COMMUNICATION from the City Plan and Zoning Commission advising that at a public hearing held July 17, 2008, the members voted 12-0 in support of a motion to APPROVE the request from James Ellis (owner) for review and approval of an amendment to the approved preliminary subdivision plat, "Deer Ridge Valley", for property located at 3301 Stanton Avenue, allowing the property to be divided into 18 lots for single-family residential development subject to the following conditions:

Deer Ridge Valley - Preliminary Plat - McKinley & Stanton Avenue 13-2008-1.19

RE: Preliminary Plat, Deer Ridge Valley

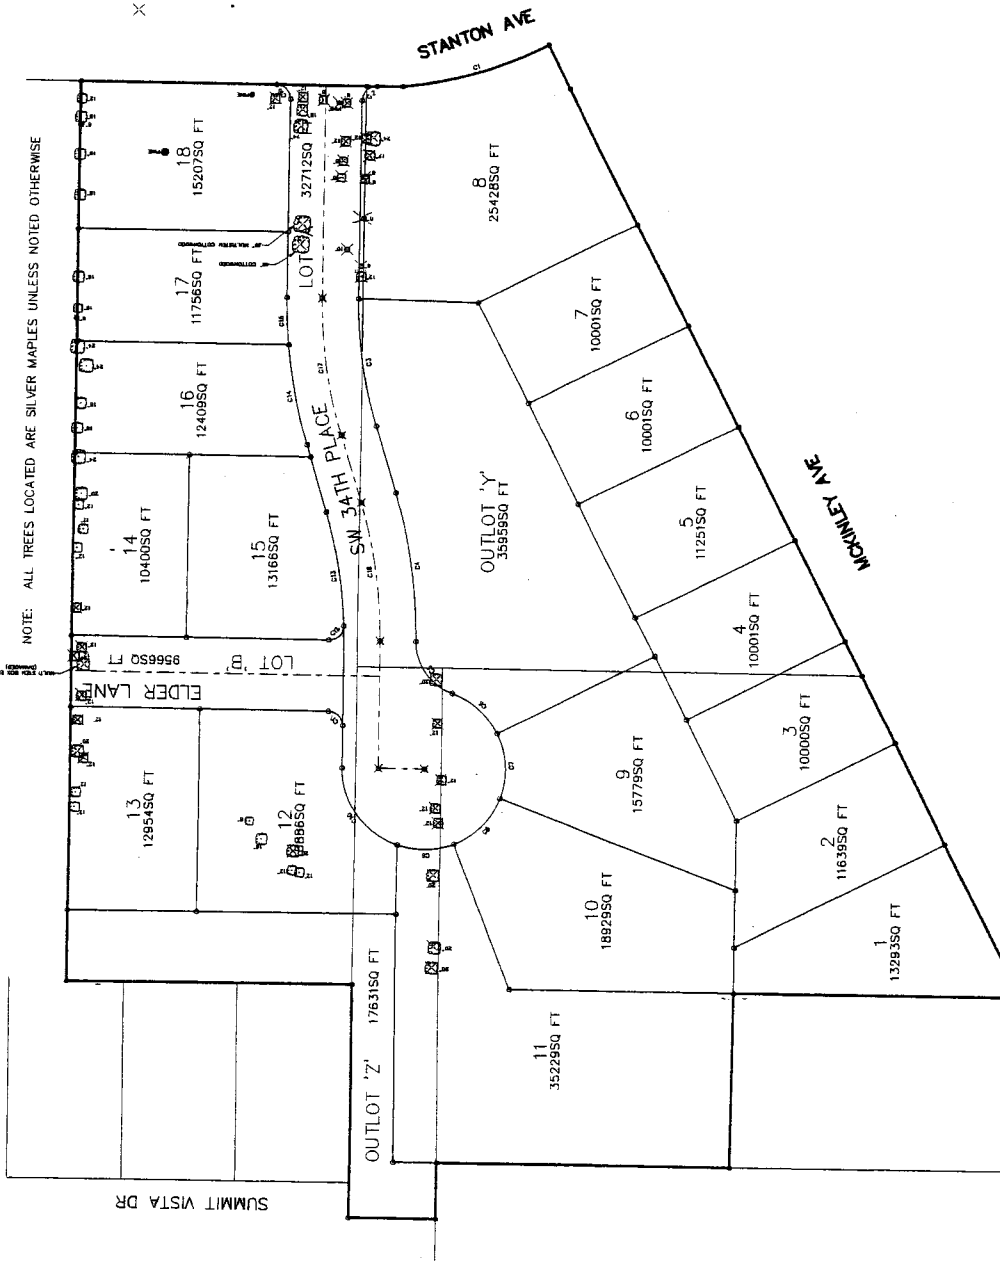
1. Provide benchmarks for survey datum.
2. Serendipity Plat Four recorded plat shows the 50' wide "Southern Hills Sanitary Sewer Easement" extending to the northern boundary of the plat, and therefore through Outlot 'Z', Lot 11 and Lot 12 of this plat.

3. The sanitary sewers on Lots 1-8 are to be offset at 7.5' and 22.5' from the edges of the easement rather than on center as shown on Sheet 3 of 3.
4. Easements for the existing 30" storm and 12" sanitary sewers within Lots 12 and 13 must be shown, including book and page numbers (remaining comments all carried over from first comment letter, unresolved).

5. The proposed use or function of the outlot shall be clearly designated on the plat.
6. Public storm sewer easements must be at least 30 feet wide and offset 7.5' / 22.5' from the center of the pipe. Reference Lot 5. "Drainage" easements are termed "Surface Water Flowage" easements in the City of Des Moines. This feature is shown in the cross-section detail on sheet 2, but it is not defined in the plan view. Correct and revise as necessary.

7. Provide a short narrative describing the proposed storm water management plan. Provide details on the design and function of the proposed drainage feature paralleling the street. Your proposed plat is subject to recently enacted amendments to the Municipal Code of Des Moines, Ordinance #14,708. Additional modifications to the plan will be needed to comply, especially Sec. 106-136.

8. Show all proposed underground utilities within the subdivision and show buildings on adjacent lots.
9. Pavement subdrain will need to be incorporated into the infrastructure design plans per the geotechnical exploration report recommendations. At a minimum, the northern half of the street appears to need a subdrain system.

10. The proposed pavement cross-section design doesn't conform to SUDAS standards as related to percent of cross-slope and center crown. The 1% slope isn't conducive to proper sheet drainage off the pavement and the "warped" pavement section will only add to the potential for future problems. Although staff isn't proposed to the concept of the surface drainage paralleling the street, it may be difficult to achieve. Your proposed design would require a request for a design exception with supporting documentation.

13. Lot 'A', the proposed public street will be Southwest 34th Place. Show the name of the street on the plat. Lot 'B', the proposed public street will be Elder Lane.
14. Show lot addresses on the plat. See the enclosed table of addresses assigned to the lots.
15. Provide the street name of all nearby R.O.W. The street name for the Summit Vista Drive R.O.W. is not shown to the NE of the proposed plat.
16. In the notes section, amend the number of lots provided to 18, rather than the 19 shown.

18. Lot #11 does not have the required 80 ft. of lot frontage at the front yard building setback line that the Zoning Ordinance requires. Furthermore, the buildable portion of the lot is severely inhibited by two sewer easements cross-crossing the property, which cannot be built on.

19. Show the frontage of all lots at the building setback line on the plat.
20. Lot #1 not meet the required minimum 10,000 sq. ft. of lot area needed in an R1-80 district.

21. Show all existing structures on the preliminary plat. There appears to be an existing house (3301 Stanton Avenue) on the SE corner of the plat.
22. Staff will be requesting the condition of utilizing shared driveways for the lots fronting McKinley Avenue to reduce the amount of approaches onto a higher speed street.

23. Staff is requesting a 10 ft. wide conservation easement to be placed on the easternmost 10 ft. of Lots 13, 14, 16, 17 & 18. Staff is requesting that the north 50 ft. of Lot 12 be a conservation easement.

24. Amend the "pointed" NW corner of Lot 9 to a configuration that more easily allow the homeowner to properly maintain the lot. Staff suggests adding this triangular portion of land to Lot 10 to cleanly remove pointed angles.
